FINAL
SUPPLEMENTAL REMEDIAL INVESTIGATION REPORT
RADIOACTIVE WASTE BURIAL SITES (SEAD-12)
SENECA ARMY DEPOT ACTIVITY

EPA Site ID# NY0213820830
NY Site ID# 8-50-006
CONTRACT NO. DACA87-02-D-0005
DELIVERY ORDER NO. 0011

PARSONS
October 2006

Response to Comments

FIGURE 2-3
TEMPORARY WELL AND
SURFACE WATER/DITCH SOIL
SAMPLE LOCATIONS

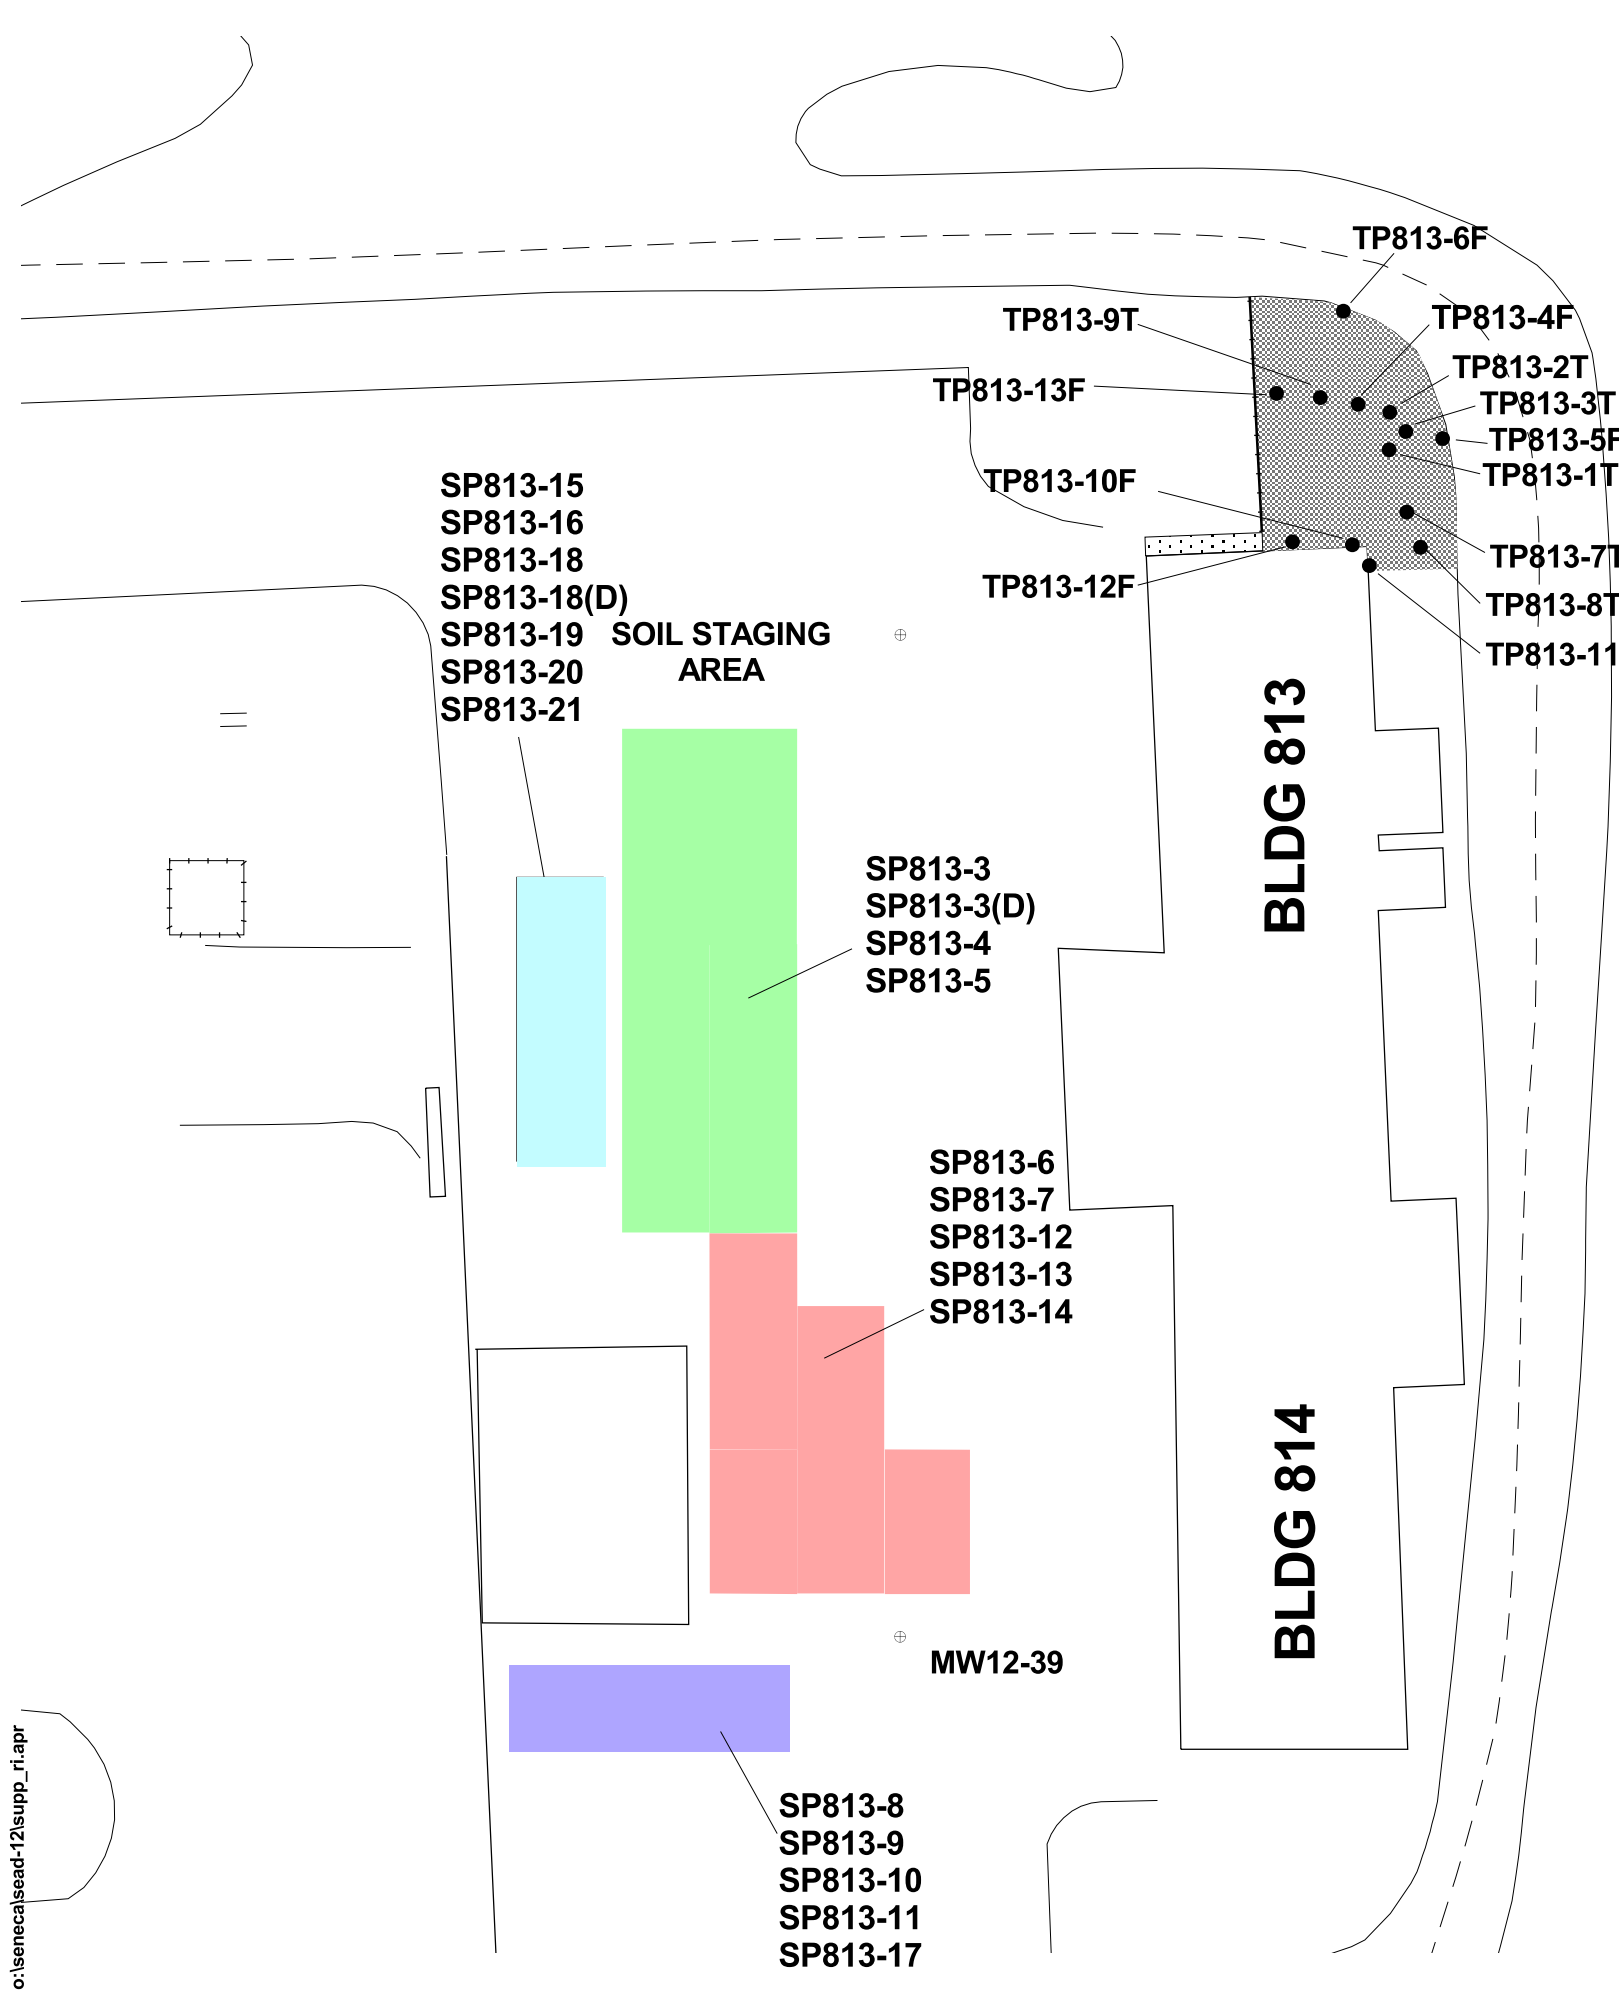
Comment 3: Section 1.3: Site Physical Characteristics, Page 1-3. Since a specific section for hydrogeological characteristics is not included in this Report, this section on site physical characteristics may be appropriate for a discussion of the groundwater flow direction at SEAD-12. Although Figures 2-1 and 2-2 of this Report do include groundwater contours from data collected in 1999, the Report has not

explicitly discussed groundwater flow direction and how it has been calculated. It is also not clear whether more recent groundwater elevation measurements may have been collected to refine the contours shown on Figures 2-1 and 2-2, perhaps using data from the temporary well installations. Please revise the Report to include a discussion of the groundwater flow direction, and indicate whether any post-1999 groundwater elevation measurements have been collected.

Comment 6: Section 2.2.2: Surface Water/Ditch Soil Investigation, Page 2-3. The description of the surface water/ditch soil samples provided in this section does not appear to correlate with the sample locations shown on Figure 2-3. For example, it is noted that sample SW/SD12-69 was cited to re-examine RI sample location SW/SD12-30. According to Figure 2-3 (Temporary Well and Surface Water/Ditch Soil Sample Locations), sample SW/SD12-69 is shown in the northern portion of the ditch, just west of temporary well sample location TW12-7. This location appears to be located nearly 300 feet away from sample SW/SD12-30, which is shown south of buildings 813 and 814 on Figure 2-1 (TCE Detected During RI). It is also noted in the text that surface water samples SW12-72 and 73 were both collected to the northwest of the elevated TCE detection at MW12-37. Figure 2-3 shows surface water

samples SW12-72 and 73 more than 200 feet south of MW12-37. Please revise Section 2.2.2 so that the sample identifications used in the description correlate with the sample identifications shown on Figure 2-3.

Response 3: Acknowledged. Groundwater elevations recorded for the temporary wells in 2004 have been included on **Figure 2-3** in the SRI report. A discussion of the groundwater flow has been included in Section 1.3 (Site Physical Characteristics).

Response 6: Acknowledged. The surface water/ditch soil sample locations were not listed correctly in Figure 2-3; the correct locations were presented in Figure 3-1. The description of the surface water/ditch soil samples provided in Section 2.2.2 matches the locations shown in Figure 3-1. Figure 2-3 has been revised to reflect the correct surface water/ditch soil sample locations and to match the Section 2.2.2 description.

Comment 7: Section 2.2.3.2: Phase II Testing Pitting – November 10 and 11, 2004, Page 2-5. Soil sample TP813-4F was collected during test pitting activities, but this sample does not appear to be shown on any figures. Figure 2-4 (Sample Locations from Test Pit at Buildings 813 and 814) should be updated to show the location of TP813-4F.

Response 7: Acknowledged. Figure 2-4 has been updated to show location TP813-4.
